Idaho Power Long Valley Operations Center
Heat Pump/Air Conditioning Water Use Estimates
2-22-2021
D. Blew – Idaho Power

From: Nelson, Dan
Sent: Thursday, January 07, 2021 11:00 AM
To: 'Boggs, Kevin/BOL'
Cc: Edl, Michele
Subject: RE: Field Report for Permit 65-23311
Attachments: 01 theoretical sheet Craigs.xls

From: Nelson, Dan <Dan.Nelson@idwr.idaho.gov>
Sent: Tuesday, October 27, 2020 2:56 PM
To: Boggs, Kevin/BOI <Kevin.Boggs@jacobs.com>
Subject: [EXTERNAL] Field Report for Permit 65-23311

From: Boggs, Kevin/BOI [mailto:Kevin.Boggs@jacobs.com]
Sent: Monday, November 23, 2020 2:52 PM
To: Nelson, Dan <Dan.Nelson@idwr.idaho.gov>
Cc: Blew, David <DBlew@idahopower.com>
Subject: Field Report for Permit 65-23311

HEAT EXCHANGER SCHEDULE

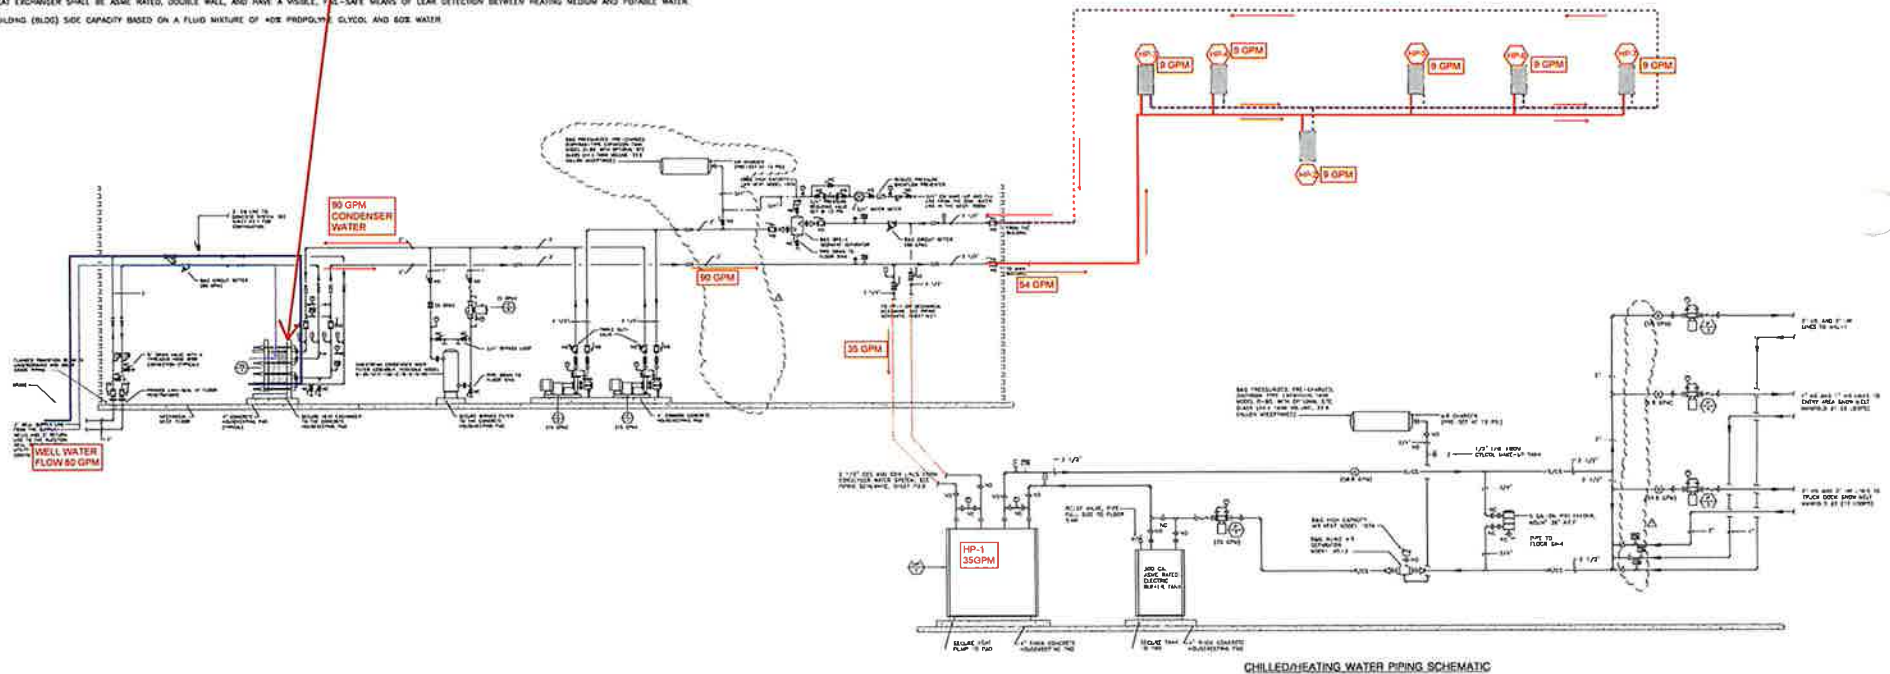
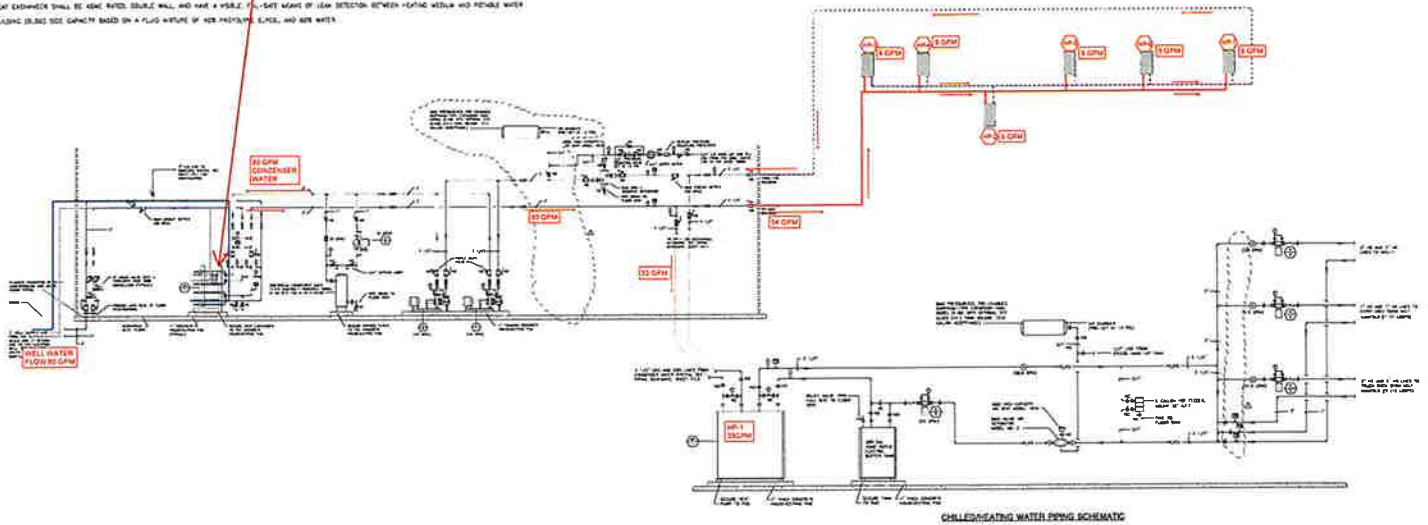
I can only recommend a diversion rate of 0.08 cfs for the heating and cooling systems, unless you can supply some additional information that shows additional flow is needed. This can come from design documents and system diagrams that show how the system operates.

I can only recommend a diversion rate of 0.08 cfs for the heating and cooling systems, unless you can supply some additional information that shows additional flow is needed. This can come from design documents and system diagrams that show how the system operates.

- The system is equipped with a supply/injection well loop and a hydronic heating/cooling closed loop (see flow diagram attached – IPC_LongValleyFacility_FlowDiagram.pdf). The water flowing through the closed loop is designed to flow at 90 gpm, and is the same water all the time (not replaced). The water in the supply/injection well loop is designed to flow at 80 gpm and is constantly replaced with water from the well; this water is re-injected into the ground.*
- The large heat pump (HP1) is a water to water heat pump and requires 35 gpm of water flow. The other 6 heat pumps (HP 2 through 7) each require 9 gpm (see attached file: HeatPump.pdf), a total of 54 gpm (see the attached file: IPC_LongValleyFacility_FlowDiagram.pdf)*

- Per the engineering design drawings (IPC_LongValleyFacility_FlowDiagram.pdf), the Heat Exchanger is scheduled for a 10 degree F temperature delta at 80 gpm.
- Noting that heat = mass flow * specific heat capacity * temperature difference, where the mass flow rate [mass/time] is a measurement of the amount of water flowing around the hot water loop. The specific heat capacity, [energy/mass/temp] is a thermodynamic property specific of the fluid used to transfer heat, water in this case. The temperature difference [temp] is the difference in temperature before and after heat transfer, 10 °F in this case. Therefore,
